**RE: Response to Request for Further Information for SSD-70316465 at 1953-2109
Elizabeth Drive, Badgerys Creek**

Burrah Park

Attachment 1 – Detailed stormwater requirements

Design comments on H&H drawings

NG_13

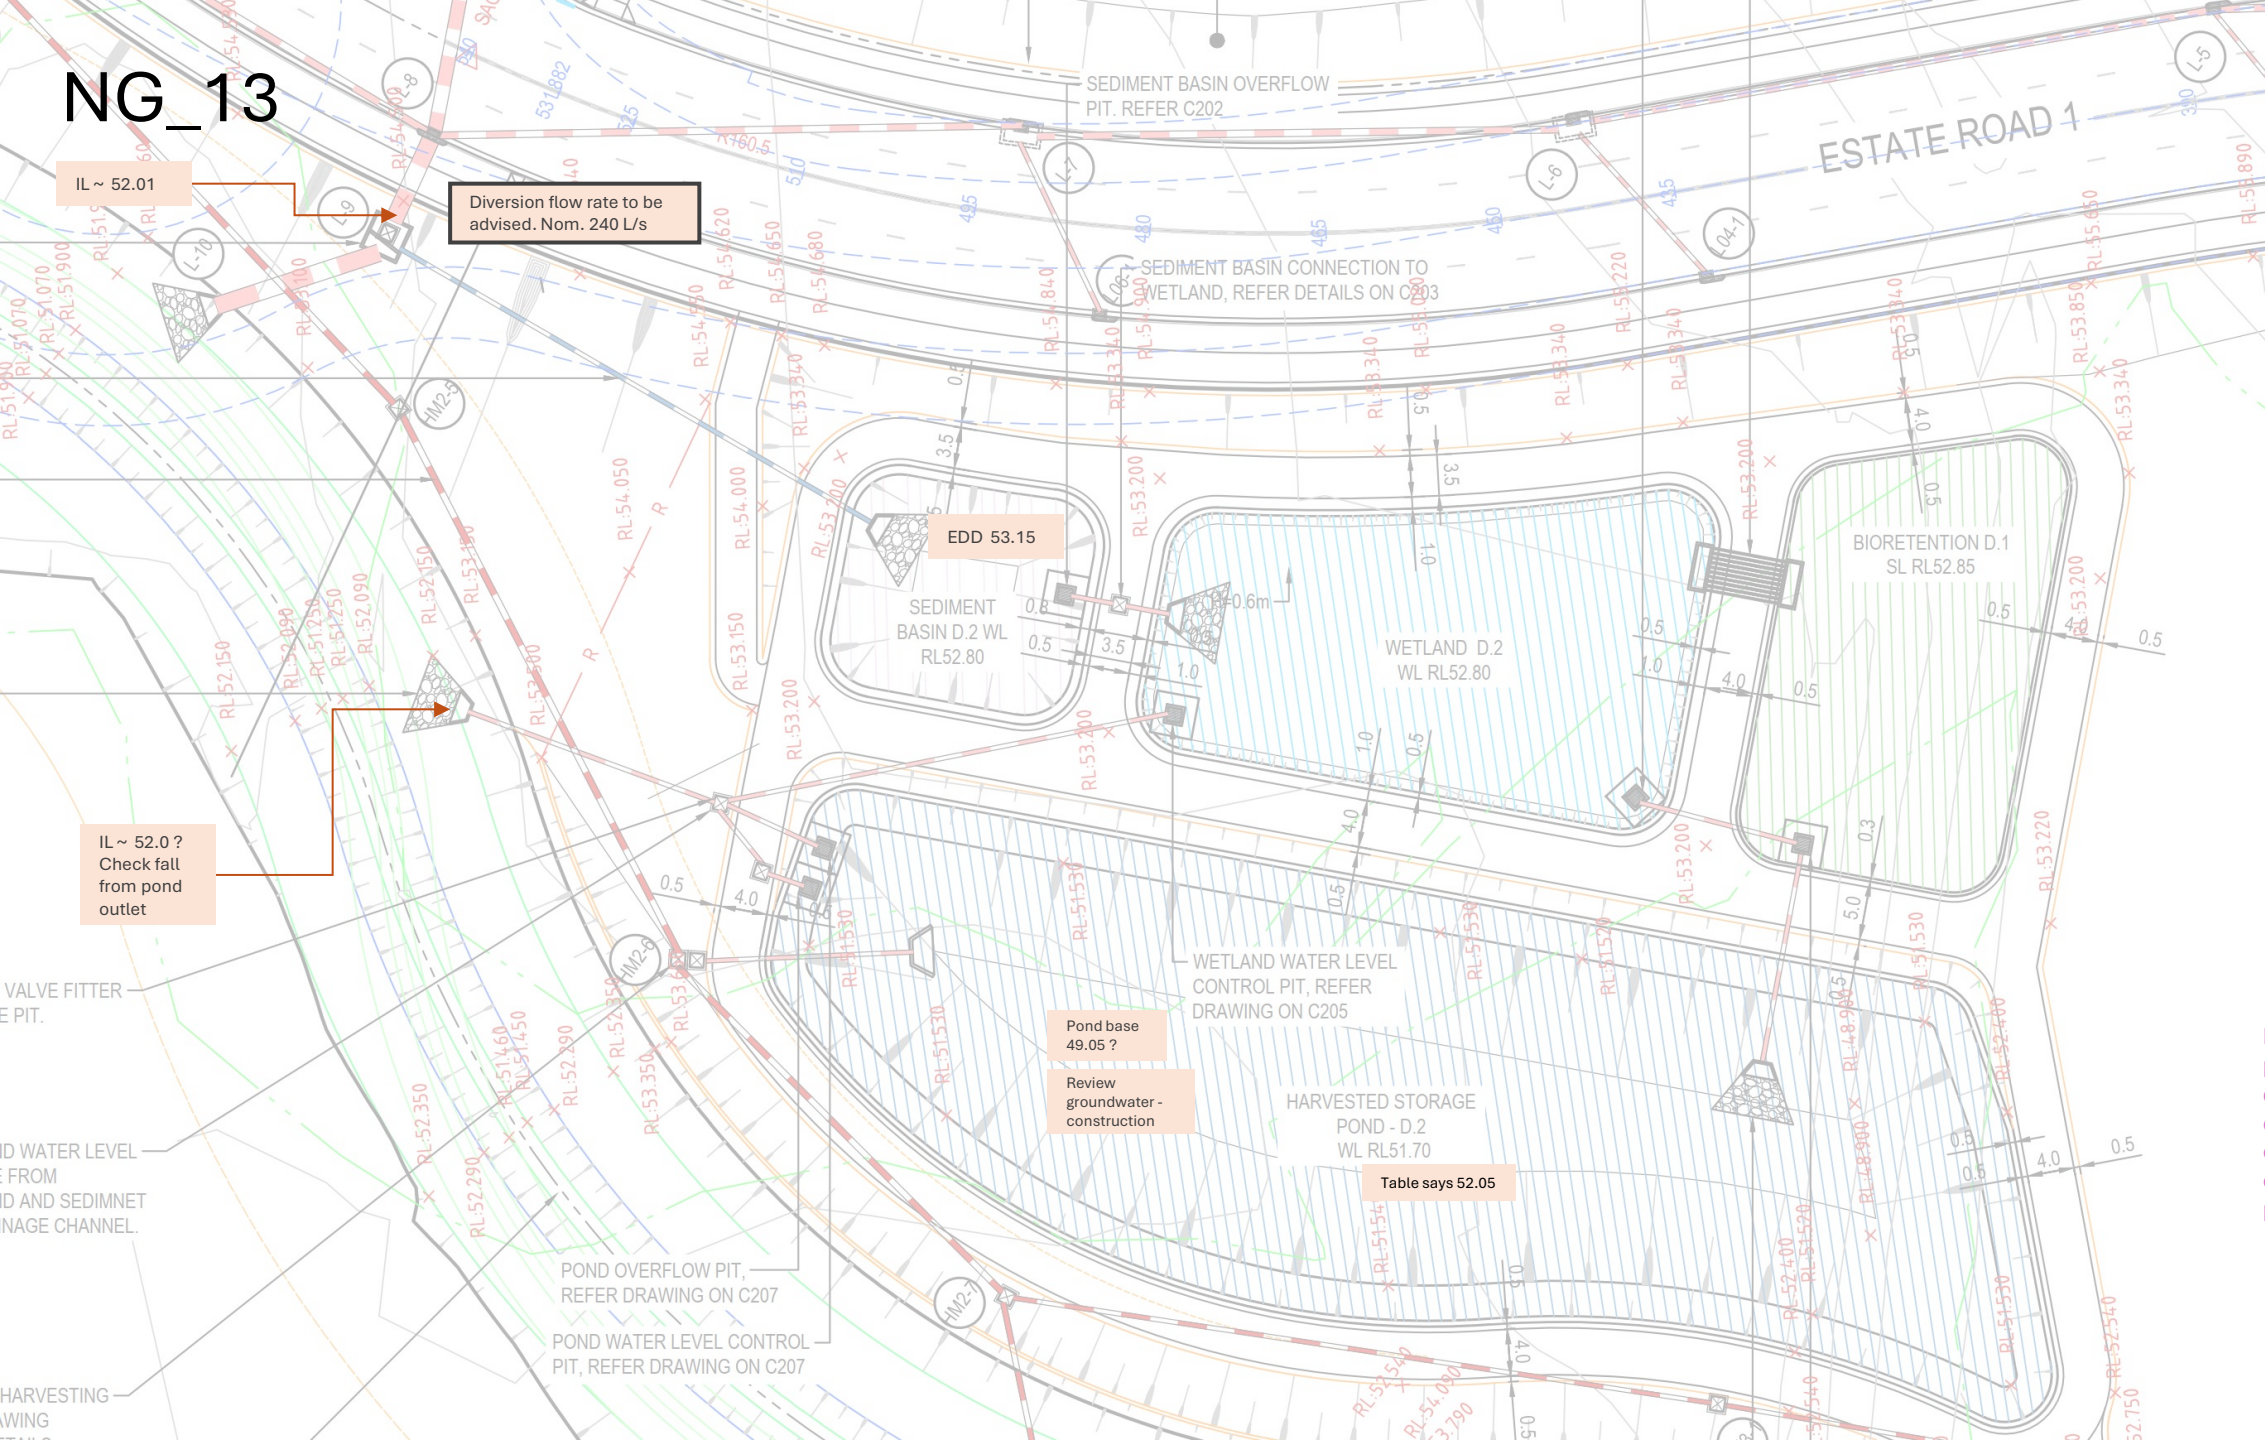
✓
NG_13 is configured as per SWC standard detail (with environmental flows to outlet and wetland overflow to storage pond)

SEDIMENT
BASIN D.1
RL54.60

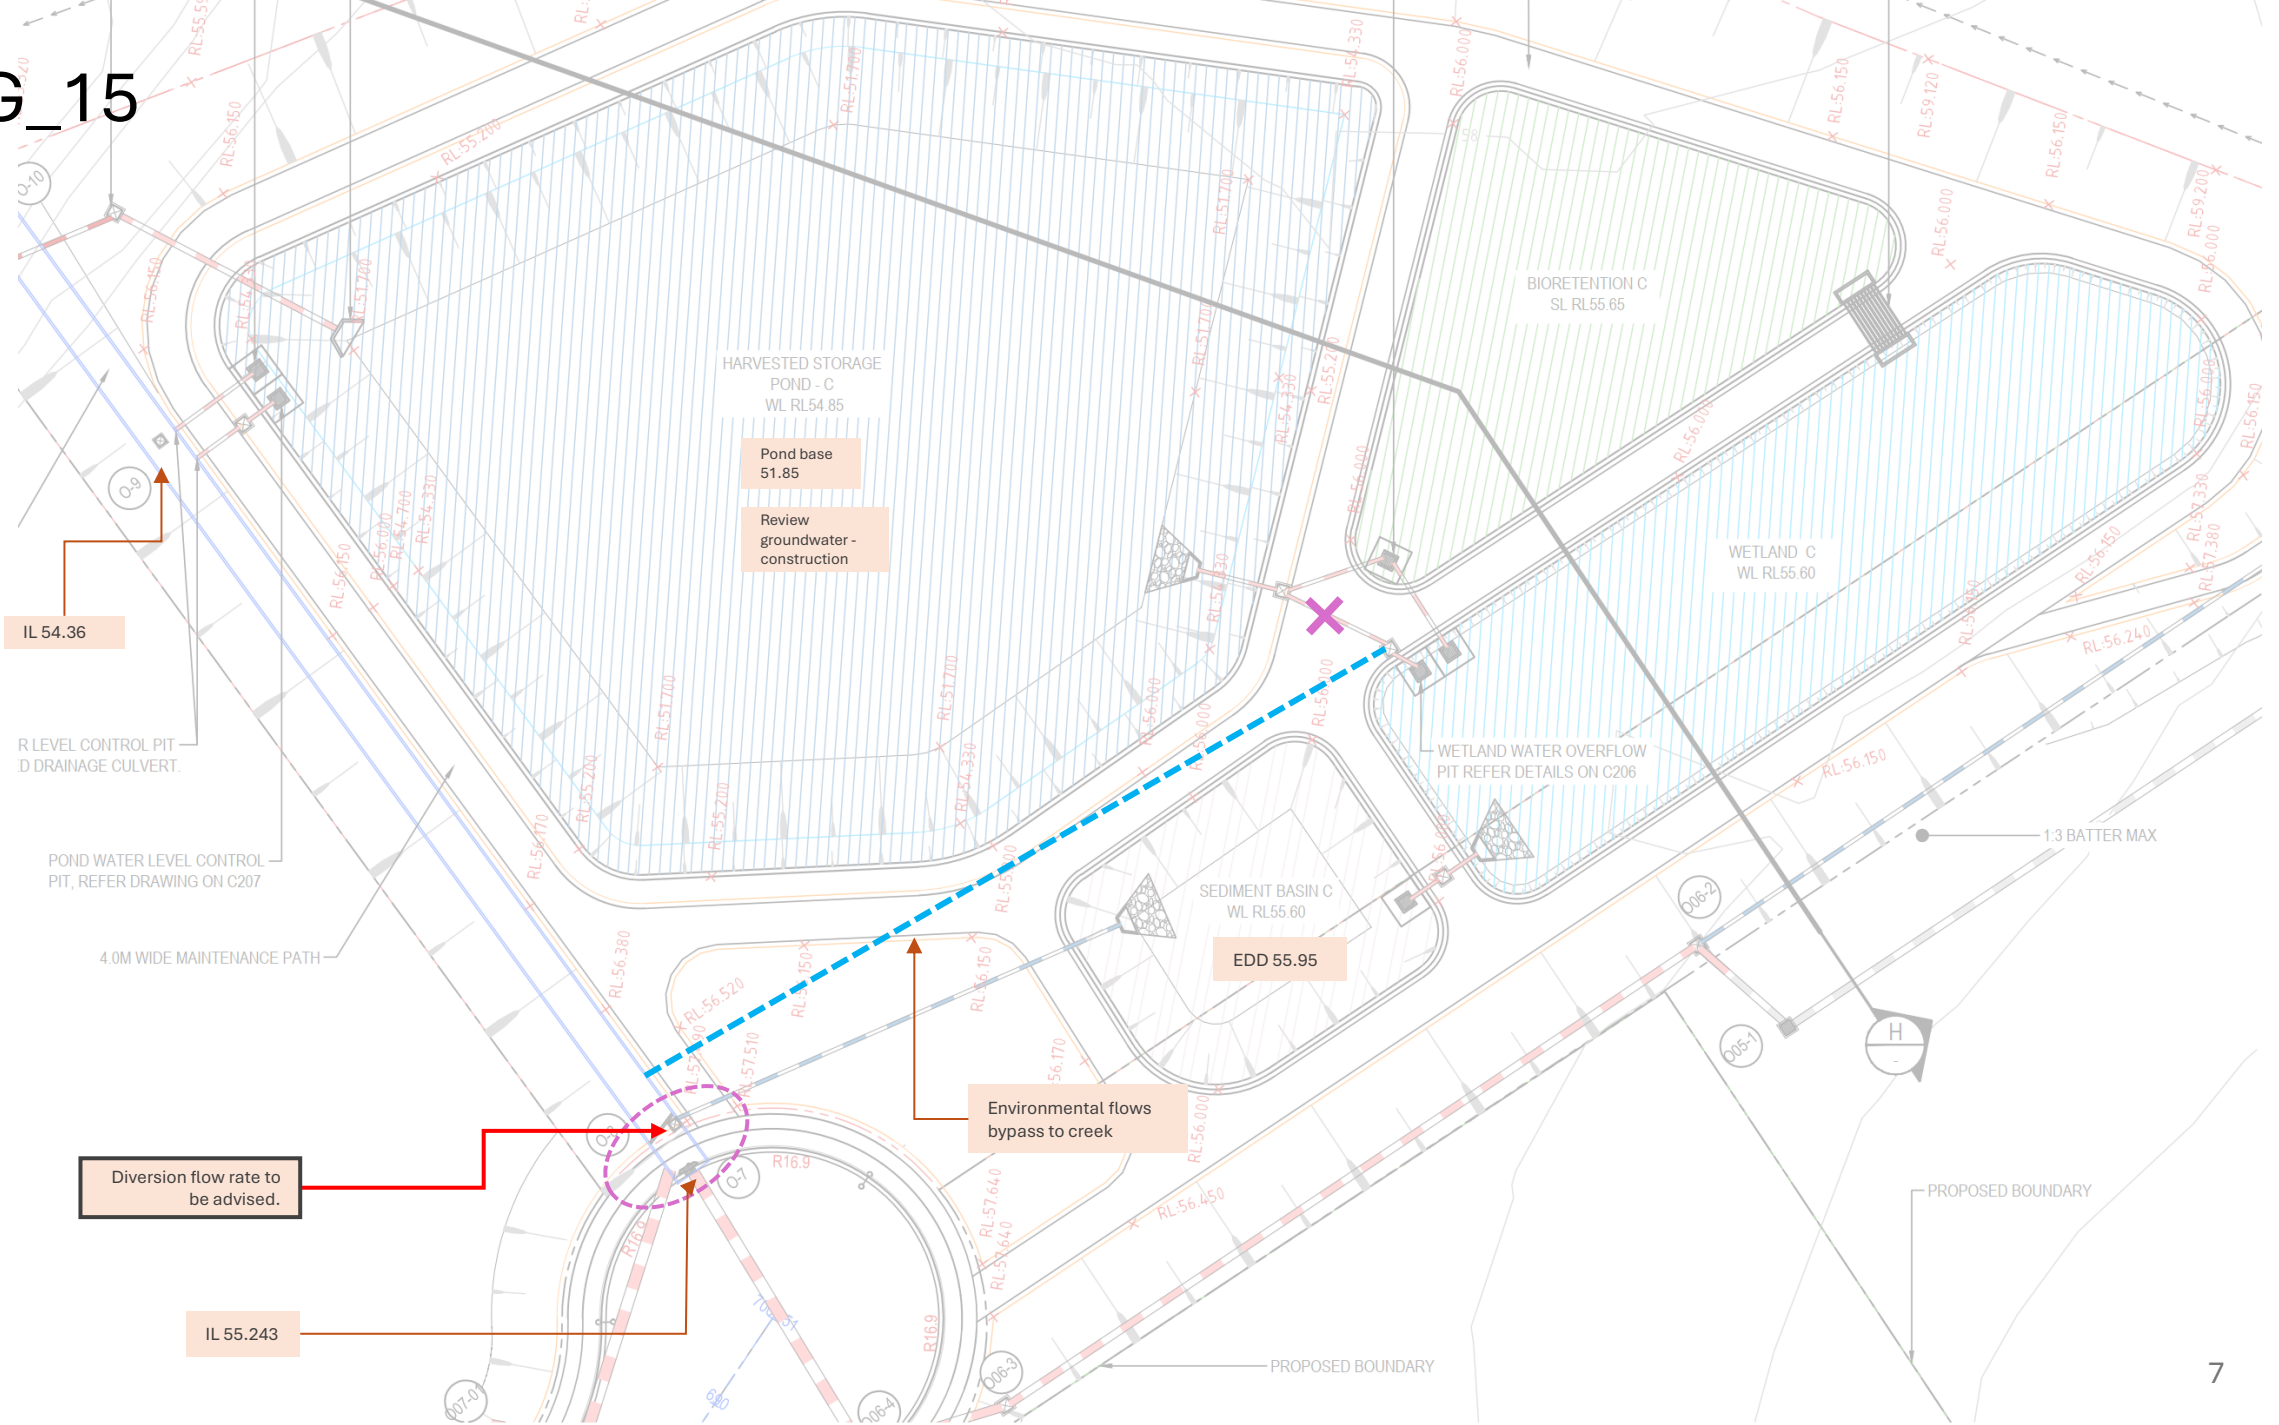
IL ~ 53.0?

Wetland normal water
level control pit
(environmental flows
bypass to creek)

Diversion flow rate to be
advised. Nom 330 L/s

Wetland overflow pit,
to harvesting pond

Review
groundwater -
construction
